**WOKINGHAM
BOROUGH COUNCIL**

SUBMISSION OF DETAILS TO COMPLY WITH CONDITIONS

LAND SOUTH OF WOKINGHAM, EAST OF FINCHAMPSTEAD ROAD AND WEST OF WATERLOO ROAD, WOKINGHAM

PLANNING PERMISSION 192928 (CONSTRUCTION OF THE SOUTH WOKINGHAM DISTRIBUTOR ROAD (SWDR) BETWEEN FINCHAMPSTEAD ROAD AND WATERLOO ROAD, INCLUDING A LINK TO HEATHLANDS ROAD, TOGETHER WITH ASSOCIATED WORKS)

Condition 5 levels (213441)

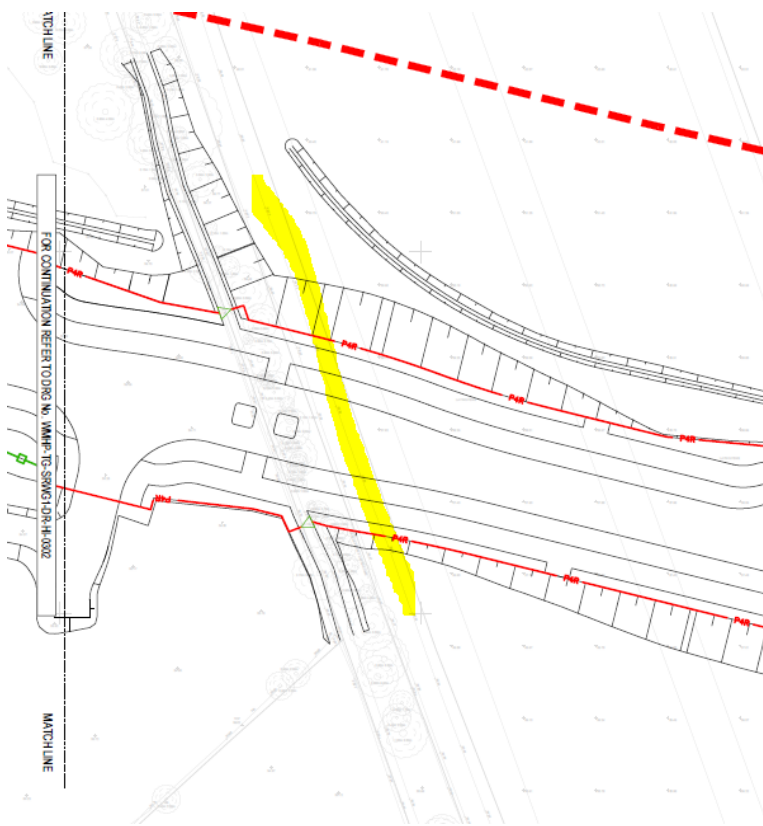
Please provide chainage drawings and longitudinal sections, as provided at the original application stage, showing existing, approved and proposed levels to allow comparison. I am aware that the consortium have raised concerns about the level of the road being increased and need to understand the scope of the issue.

and on WMHP-TG-SRWG1-DR-HI-301:

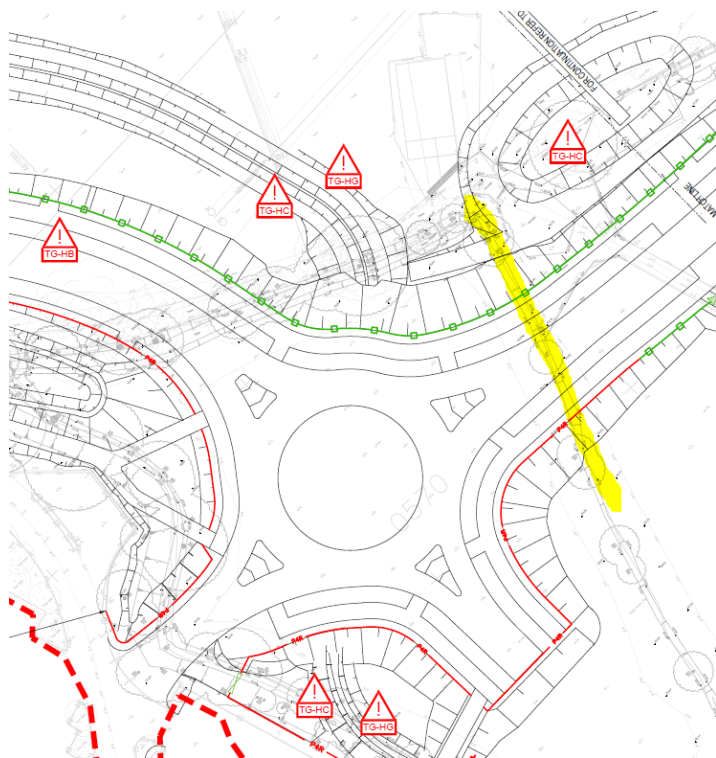
Additional mammal tunnels are required in these two locations, with reference to the fencing plans, on WMHP-TG-SRWG1-DR-HI-0303 (highlighted yellow):

Condition 11 AMS (213554)

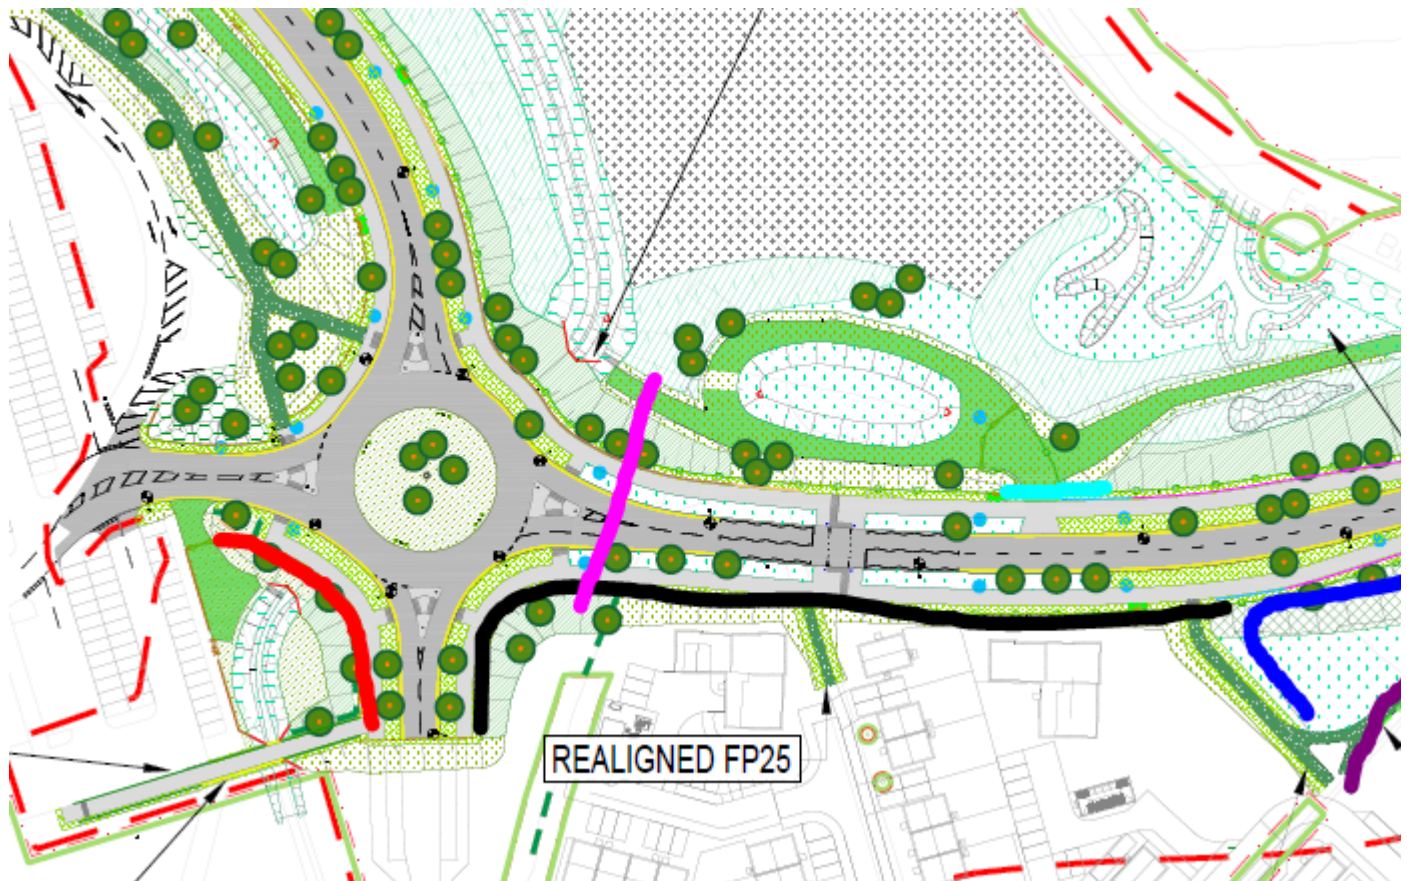
A revised AIA has been submitted but not an AMS which will need to be submitted to comply with this condition.
